BLYTHE MESA SOLAR PROJECT

Final Environmental Impact Report/Environmental Assessment

APPENDIX O
RESPONSES TO COMMENTS

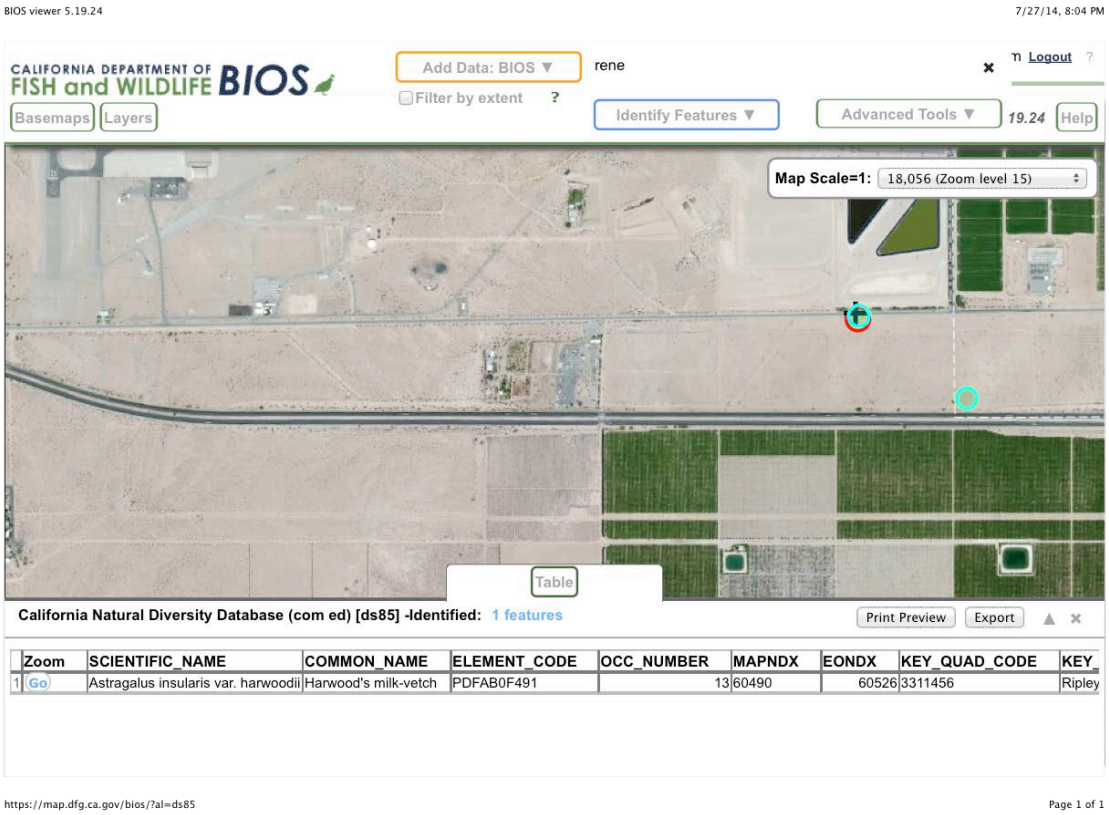
Harwood's woollystar (*Eriastrum harwoodii*) occurs within all three potential gen-tie corridors.[1] Harwood's milk-vetch (*Astragalus insularis* var. *harwoodii*) occurs on the Project site (Figure 1) and within the northern gen-tie line corridor.[2] Harwood's woollystar has a Rare Plant Rank of 1B.2, which indicates it is rare throughout its range and fairly endangered in California.[3] The species has a global rank of G2 and a state rank of S2, which indicates it is "at high risk of extinction due to very restricted range, very few populations (often 20 or fewer), steep declines, or other factors" at both the statewide and global scale.[4] Harwood's milk-vetch has a Rare Plant Rank of 2.2, which indicates it is rare or endangered in California, but more common elsewhere.[5] The species has a state rank of "S2.2?," which represents slightly less certainty than a rank of S2.[6]

Figure 5. Ponds adjacent to the boundary (yellow line) of the northern portion of the Project site.

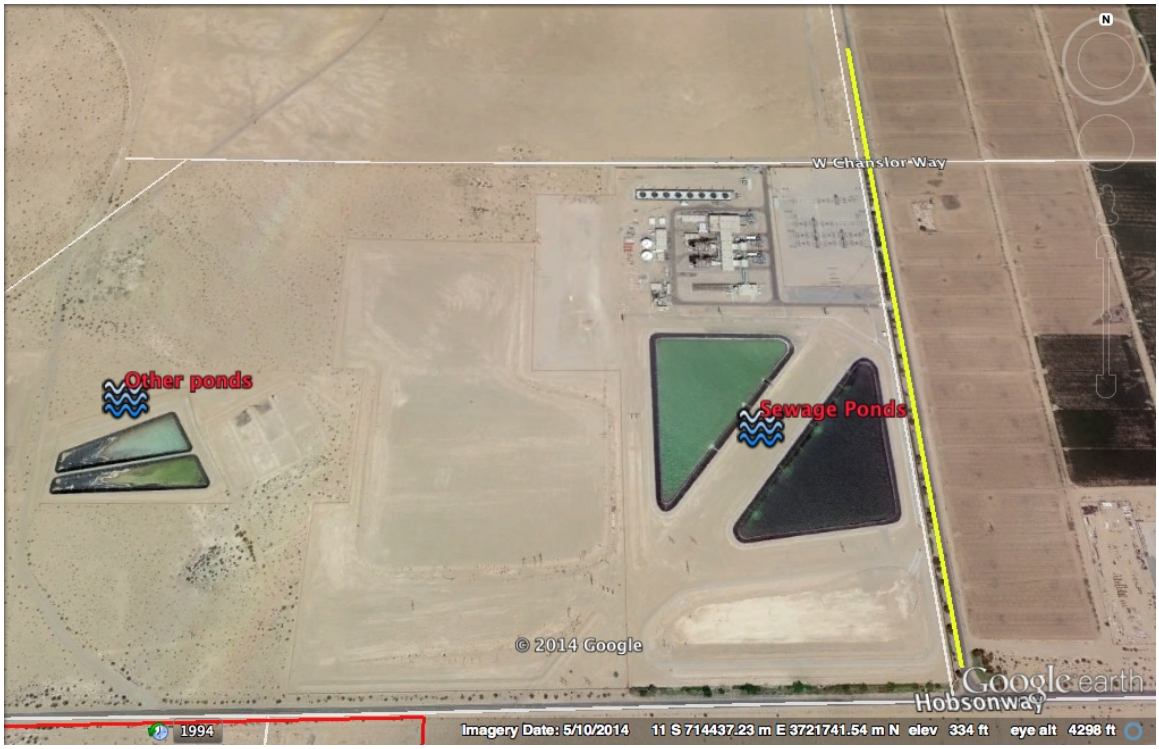
Although the Project will not have evaporation ponds, the northern portion of the Project site is located immediately adjacent to two sewage treatment ponds, and two other ponds of unknown use (Figure 5). Sewage treatment ponds are known to attract an abundance of birds due to the food they supply.[52] Based on my calculations, the sewage treatment

ponds adjacent to the Project site are approximately twice as large as the evaporation ponds adjacent to the Desert Harvest facility (Figure 6).

Figure 7. Other potential burrowing owl mitigation lands (red polygons) identified by the Applicant. Corresponds to *Western Burrowing Owl Monitoring and Mitigation Plan*, Figure 4.

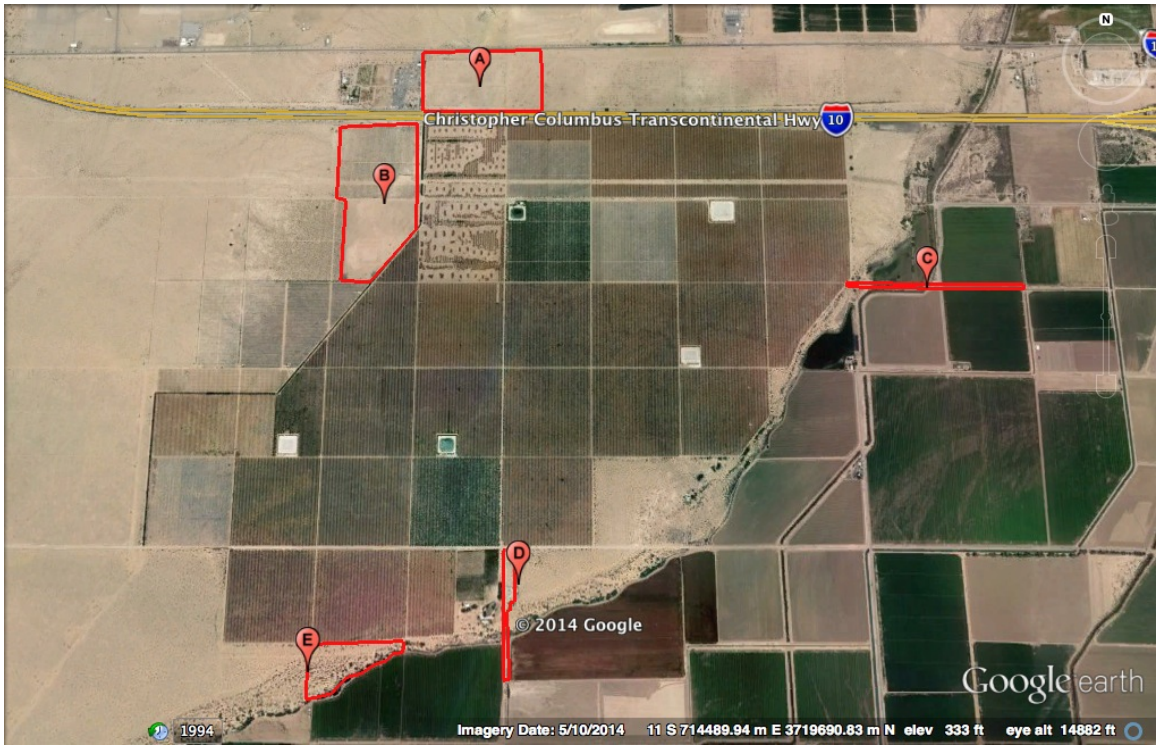
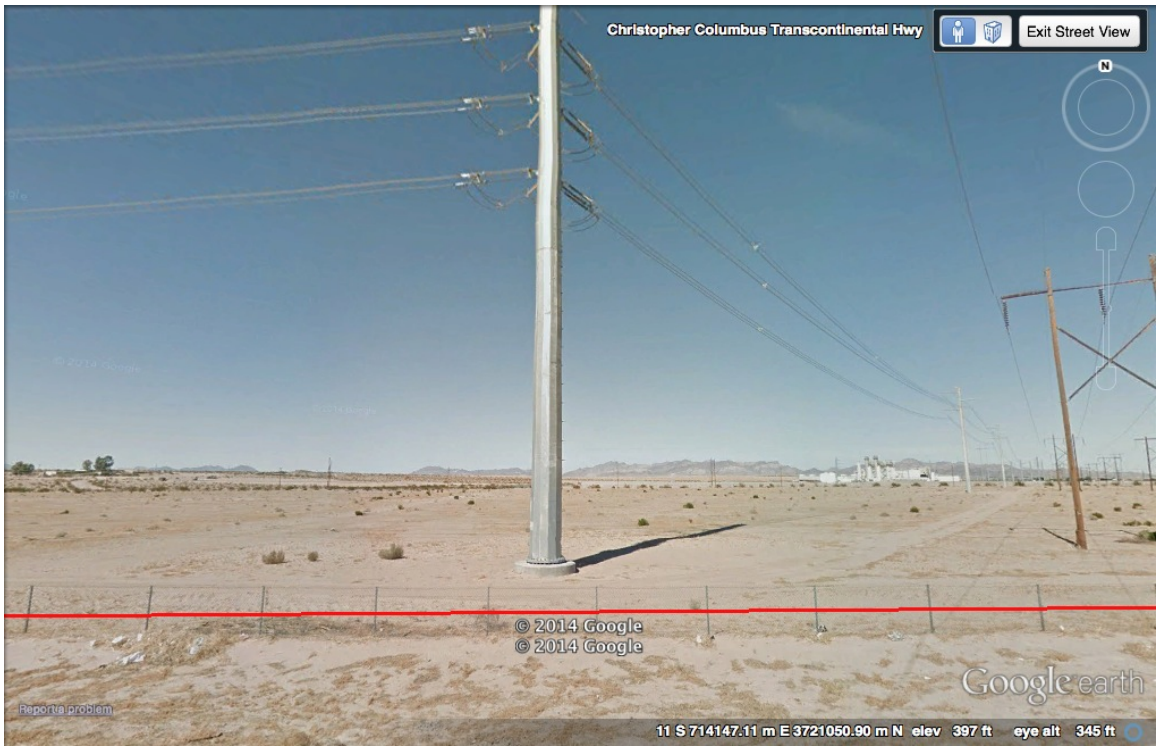
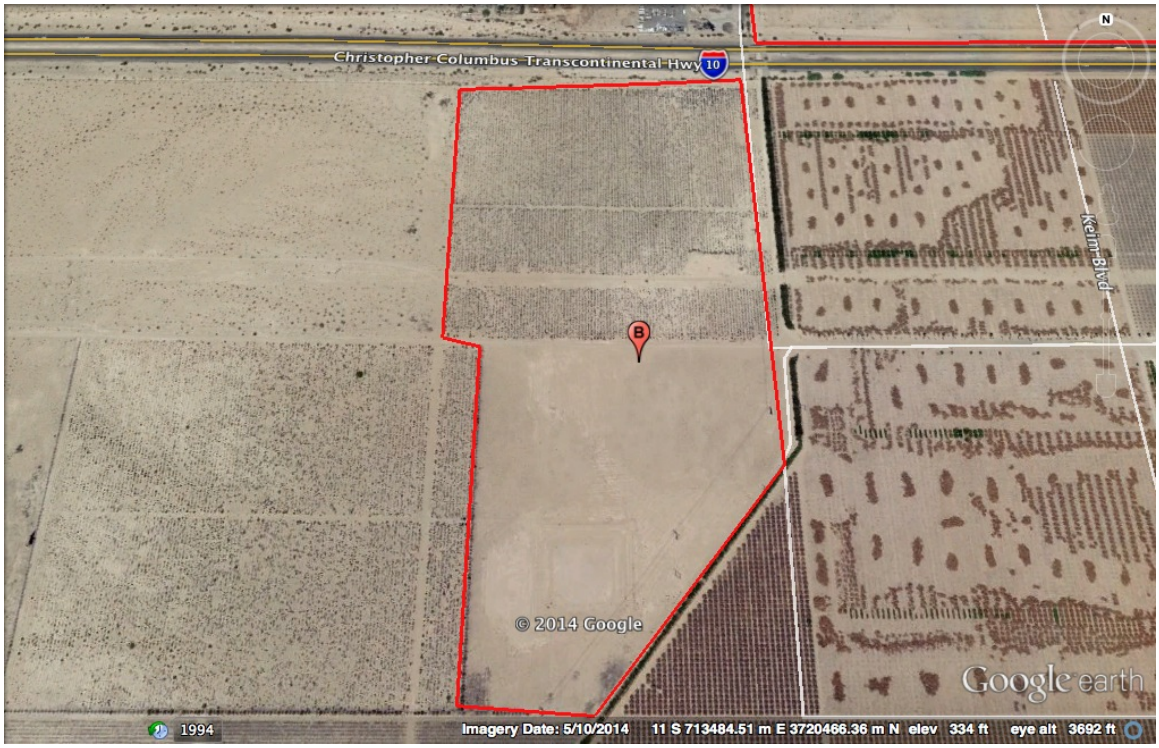
Second, the DEIR/DEA fails to provide any evidence that there are suitable mitigation sites in the Chuckwalla Valley. It also fails to establish conditions (e.g., occupancy by Mojave fringe-toed lizards) that ensure the mitigation site(s) has any value to the conservation of the species in the Chuckwalla Valley. Based on the cumulative impacts map (Figure 4), acquisition of mitigation sites in the Chuckwalla Valley may not be feasible. If this inference is correct, the County and BLM need to analyze the potential fate of the Chuckwalla Valley population, and justify the value that potential mitigation sites elsewhere would have to the overall conservation of the species.

Project No.: 523	Drawn By: JAC	Figure: 1
SWAPE	Approved: MFH	Date: 08.21.2012

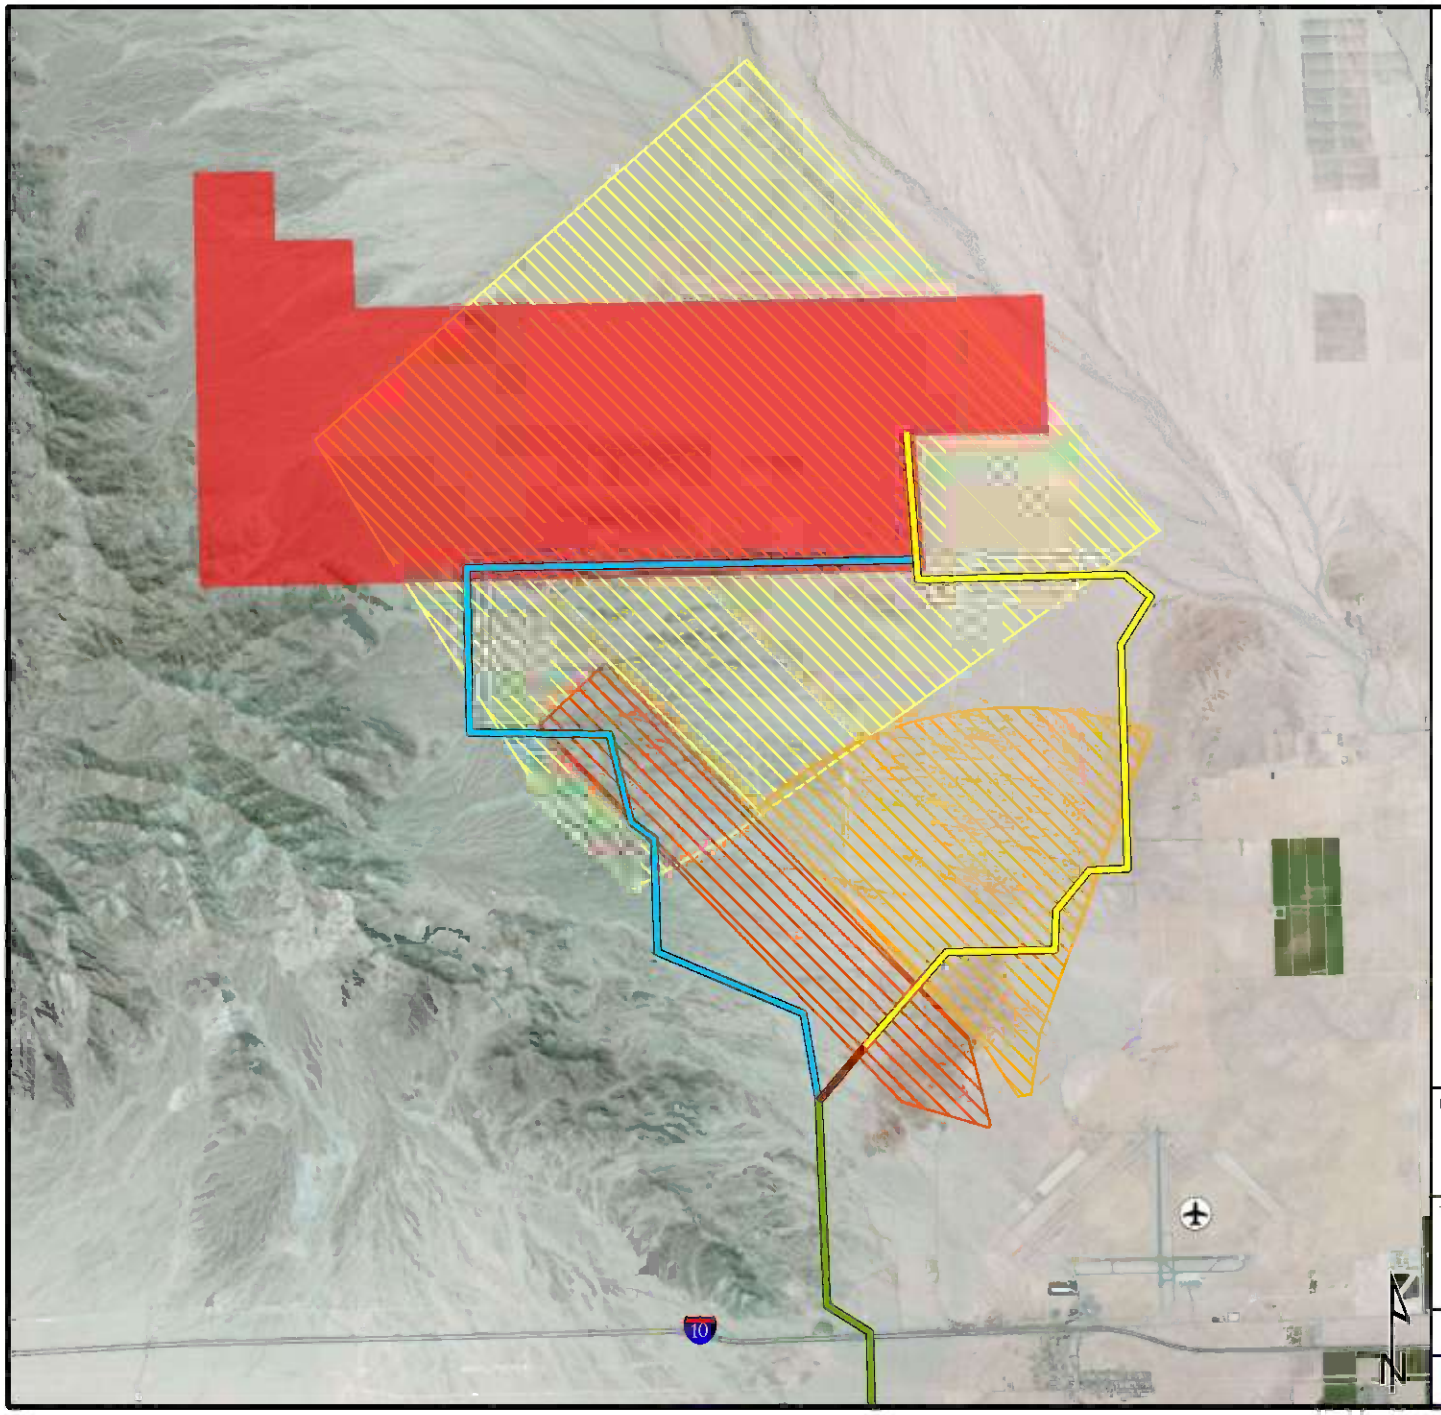
We have mapped the FUDs boundary and associated features including firing ranges and a practice bombing area (Figure 1, Attachment A). As shown in the figure, areas where bullets were scattered from target practice (known as "safety fans") are located approximately 4000 feet south of the Project site footprint. Tie lines for power transmission cut across both safety fans. The practice bombing range underlies a majority of the Project area.

guns. The safety fan associated with the Poorman Range at the Blythe AAF is shown in Figure 1 to extend more than five miles to underlie the eastern and western generator tie line alignments being considered for power transmission lines.

Jeep Ranges were used to simulate moving targets for trainees using .30 and .50 caliber machine guns. The Jeeps were guided on tracks behind an earthen bunker with the target extending above the berm.[15] Figure 1 shows the Jeep Range to underlie the eastern generator tie line alignment and an access road.

Project No.: 523	Drawn By: JAC	Figure: 2
SWAPE	Approved: MFH	Date: 08.21.2012

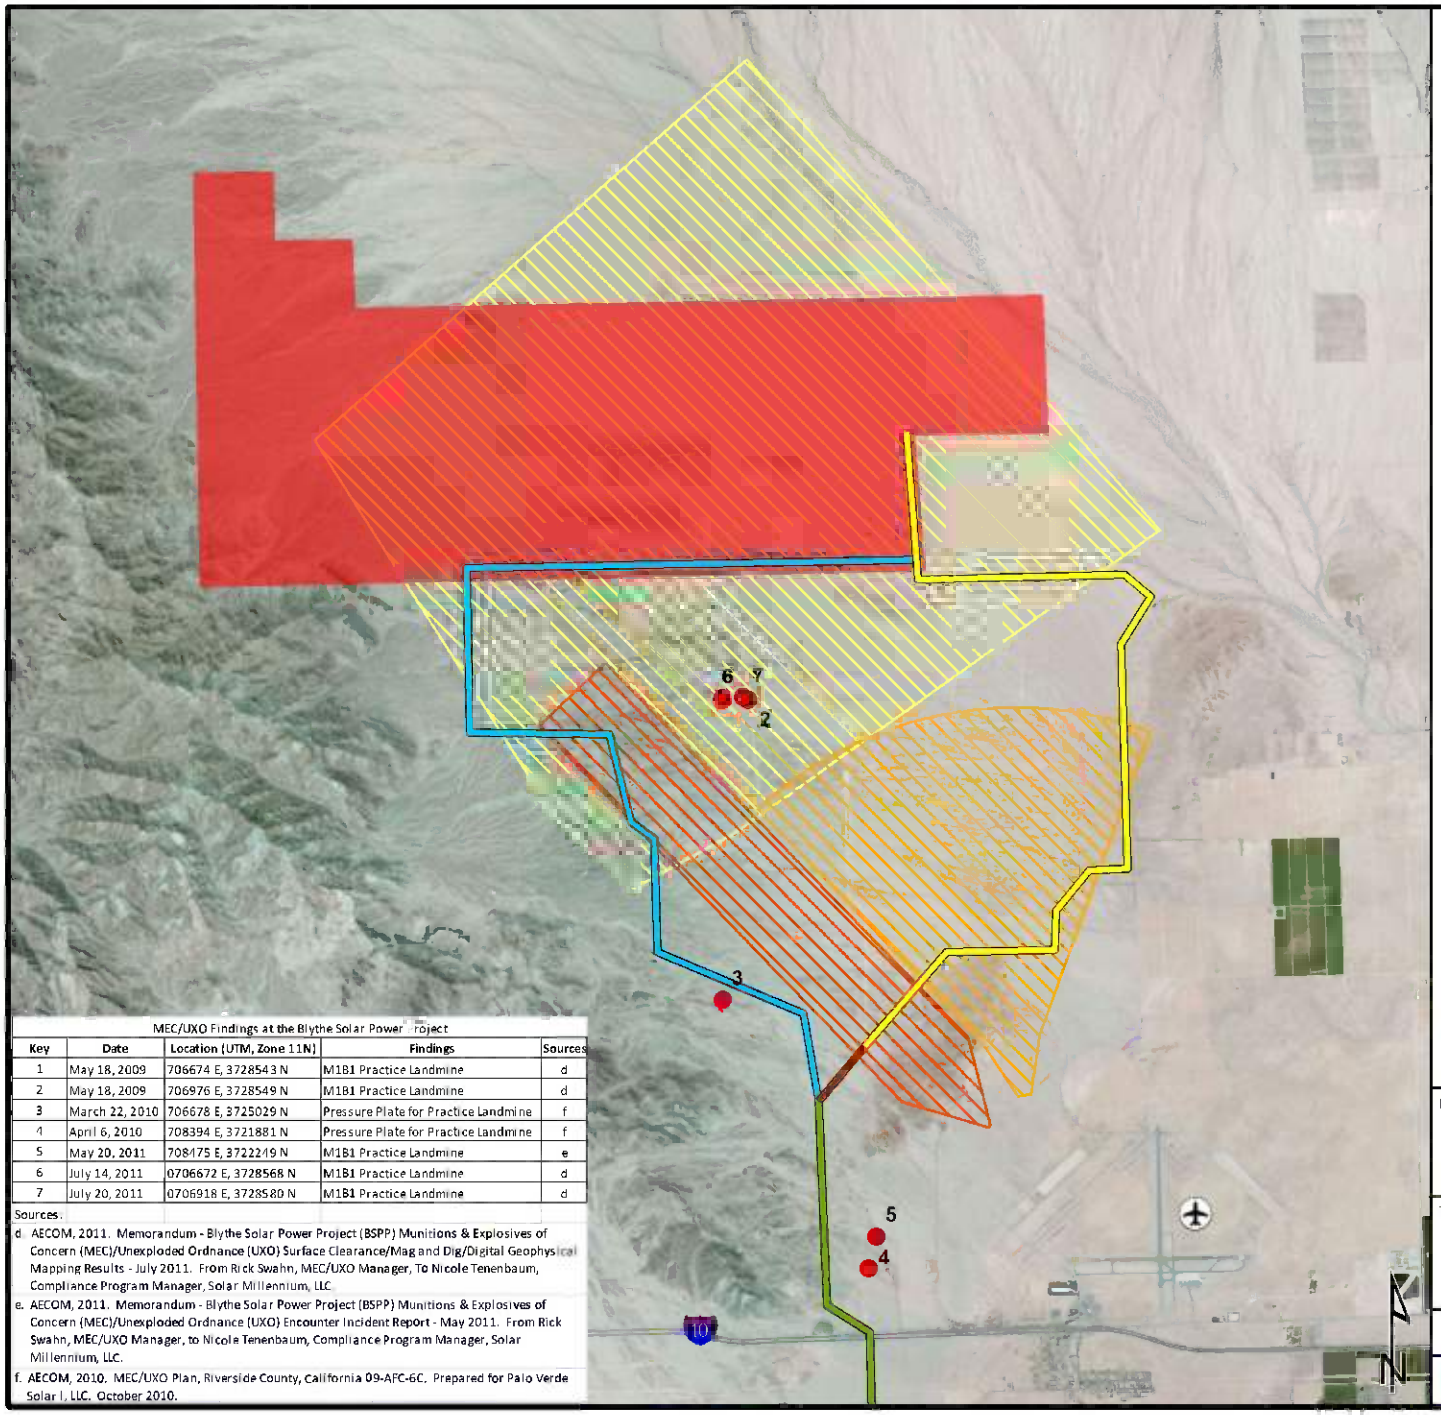
UXO has been documented in association with the neighboring Blythe Solar Power Project (BSPP), located within less than 500 feet south of the Project site. During construction of the BSPP, seven separate UXO-related material findings have been reported. These incidents are documented in Monthly Compliance Reports and associated attachments, which were prepared by the applicant and submitted to the California Energy Commission. We obtained these reports and have created a map to show where UXO have been found (Figure 2, Attachment B). These findings are also described in the table below.

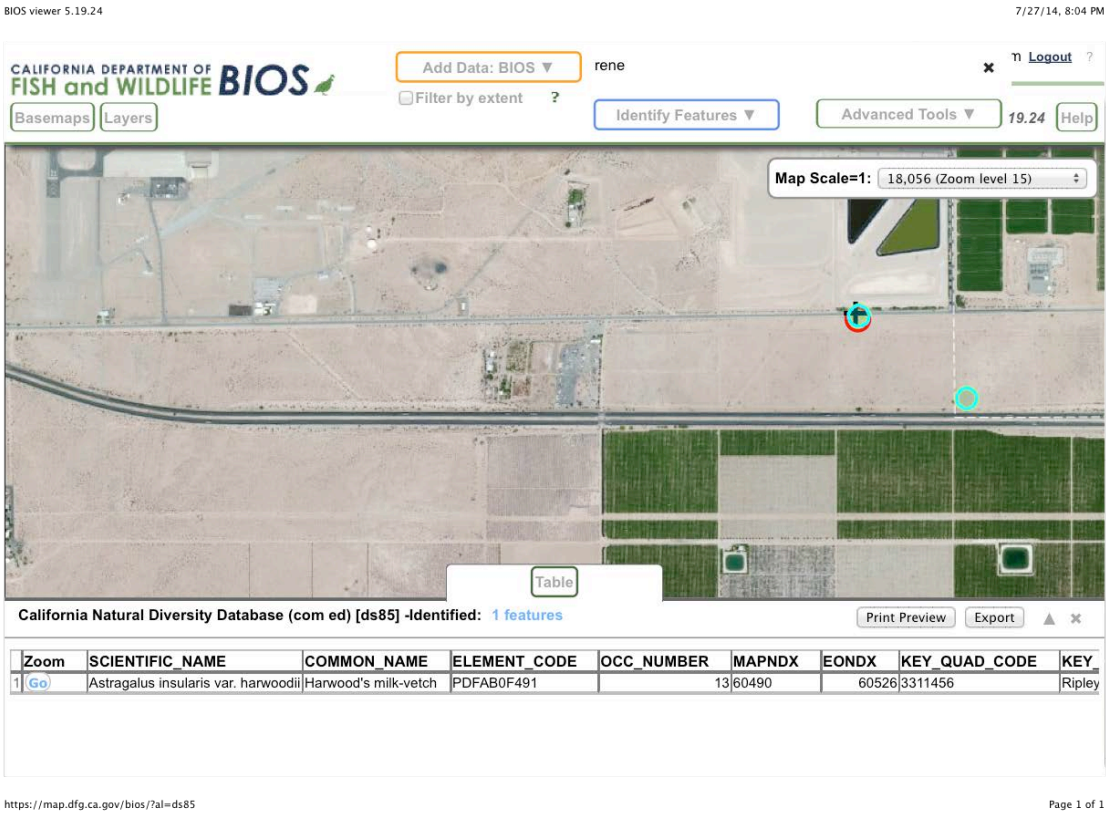
Harwood's woollystar (*Eriastrum harwoodii*) occurs within all three potential gen-tie corridors.[1] Harwood's milk-vetch (*Astragalus insularis* var. *harwoodii*) occurs on the Project site (Figure 1) and within the northern gen-tie line corridor.[2] Harwood's woollystar has a Rare Plant Rank of 1B.2, which indicates it is rare throughout its range and fairly endangered in California.[3] The species has a global rank of G2 and a state rank of S2, which indicates it is "at high risk of extinction due to very restricted range, very few populations (often 20 or fewer), steep declines, or other factors" at both the statewide and global scale.[4] Harwood's milk-vetch has a Rare Plant Rank of 2.2, which indicates it is rare or endangered in California, but more common elsewhere.[5] The species has a state rank of "S2.2?," which represents slightly less certainty than a rank of S2.[6]
